UNITED STATES PATENT AND TRADEMARK OFFICE

Application No.	Applicant(s)	
Office Action Summary		10/065,394	CADIMA, PAUL BRYAN	
		Examiner	Art Unit	
		Kathryn Ferko	3743	
	- The MAILING DATE of this communication ap		h the correspondence address	
Period fo	• •			
THE N - Exten after to - If the - If NO - Failur - Any fo	ORTENED STATUTORY PERIOD FOR REPL MAILING DATE OF THIS COMMUNICATION. sions of time may be available under the provisions of 37 CFR 1. SIX (6) MONTHS from the mailing date of this communication. period for reply specified above is less than thirty (30) days, a reperiod for reply is specified above, the maximum statutory period to reply within the set or extended period for reply will, by statuteply received by the Office later than three months after the mailing digital patent term adjustment. See 37 CFR 1.704(b).	136(a). In no event, however, may a re bly within the statutory minimum of thirty will apply and will expire SIX (6) MONT e. cause the application to become AB	ply be timely filed (30) days will be considered timely. THS from the mailing date of this communication. NDONED (35 U.S.C. § 133).

DETAILED ACTION

This is a response to the amendment dated May 30,

Appendix

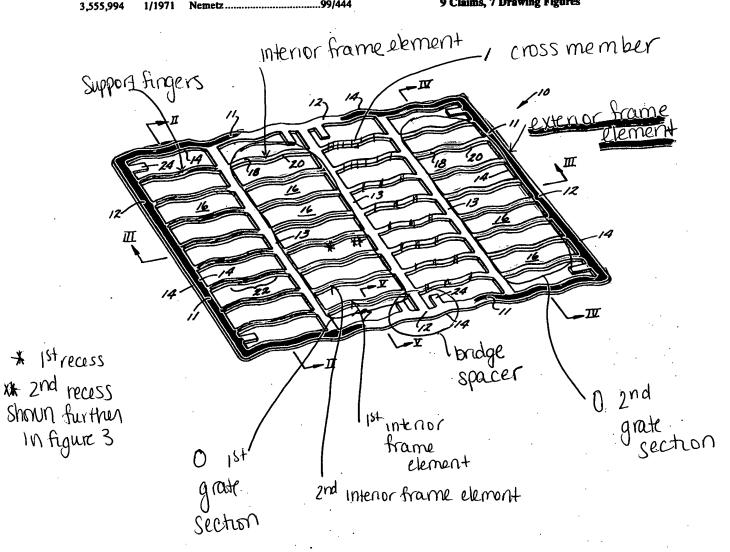
With regard to claims 1-5, Karapetian discloses a cooking grate (shown generally at 10) having a frame with an exterior frame element (11); at least one interior frame element (18/20 as labeled in the Appendix) having a cooking utensil supporting surface elevated from the exterior frame element, as seen in figure 3; at least one recessed surface (22) extending from the cooking utensil supporting surface where a top of the recessed surface is separated from the top of the cooking utensil supporting surface, thereby providing a gap for passage of a burner flame, as recited in column 3, lines 1-31 and seen in figure 3; a grate having a first interior element (18/20 as labeled in the Appendix) and a second interior element (also 18/20 as labeled in the Appendix) where each of the first interior element and second interior element have a recessed surface, as seen in figures 1 and 3; a plurality of support fingers (18/20 as labeled in the Appendix) extending from the interior frame element and exterior frame element; support fingers that are elliptical arcs, as seen in figure 3 (the undulations - no point of reference/plane had been established to define the elliptical arcs or the manner in which they extend); and a cooking grate the is substantially rectangular, as seen in figure 1.

Regarding claims 6-10, Karapetian discloses a grate assembly for a cooking appliance having at least one exterior frame element (11); at least one support finger (18/20 as shown in the Appendix) extending from the exterior frame where the support finger has a top surface extending above at least one exterior frame element, as seen in figure 3; at least one interior frame element (18/20 as shown in the Appendix) having a top surface extending above the exterior frame element, as shown in figure 3; a top surface of the interior frame element that is substantially coplanar with the top surface of the support finger, as seen in figures 1 and 3; at least one recessed surface (22) extending from the top surface of the interior frame element; the recessed surface defining a clearance for passage of a burner flame, as seen in figure 3; a first grate section (labeled in the Appendix); a second grate section (labeled in the Appendix); and a bridge spacer section (at 14 as labeled in the Appendix); at least one of the first grate section and second grate section that has a cross member frame (as labeled in the Appendix) element substantially dividing the grate section; the at least one recessed surface located in the cross member frame element, as seen in figure 1; at least one interior frame element that has a first recessed surface and a second recessed surface (22 as seen in the Appendix); and a grate assembly that is substantially rectangular, as seen in figure 1.

shown in figure 1; at least one interior frame element (18/20 as labeled in the Appendix) with a top surface; a cross member (as labeled in the Appendix) frame element with a top surface where the cross member frame element extends between the exterior frame element and the interior frame element, as shown in figure 1; top surfaces of the interior cross member frame element and interior frame element that are substantially coplanar and elevated relative to a top surface of the exterior frame element, as shown generally in figure 3; at least one of the cross member frame element and interior frame element has a recessed surface (22) extending from the coplanar surface, where the recessed surface has a flame clearance gap, as seen in figure 3; a recessed surface that is approximately centered in the cross member frame element, as seen in figure 3; at least one support finger extending from the frame, the support finger (labeled in the Appendix) extending in an elliptical arc, as seen in figures 1 and 3; a bridge spacer (as labeled in the Appendix) having a top surface coplanar with the top surface of the interior frame element and at least one recessed portion extending from the top surface of the bridge spacer section, as seen in figures 1 and 3; and a recessed surface that is concave, as seen in figure 3.

Regarding claims 17-20, Karapetian discloses a grate assembly having an interior frame element (18/20 as labeled in the Appendix) extending between the; an interior frame element having a cooking utensil surface and a flame clearance recessed portion (22) extending from the cooking utensil surface, as seen in figures 1 and 3; the grate assembly having a first grate section, a second grate section, and a bridge spacer (as seen in the Appendix) there between; an interior cross member frame element (shown in the Appendix), and a recessed portion(22) substantially centered in the cross member frame element, as seen in figures 1 and 3.

With regard to claims 22-26, Karapetian discloses a first grate section (as labeled in the Appendix); a second grate section (as labeled in the Appendix); a bridge spacer section (shown in the Appendix) extending between the first grate section and second grate section; a top surface of each of the first grate section, second grate section, and bridge spacer having a substantially coplanar utensil supporting surface, as seen in figures 1 and 3; a recessed portion (22) extending from the utensil supporting surface; a recessed surface portion (22) that is substantially centered, as seen in figure 3; and at least one of the first and second grate sections that is substantially rectangular, as seen in figure 1.
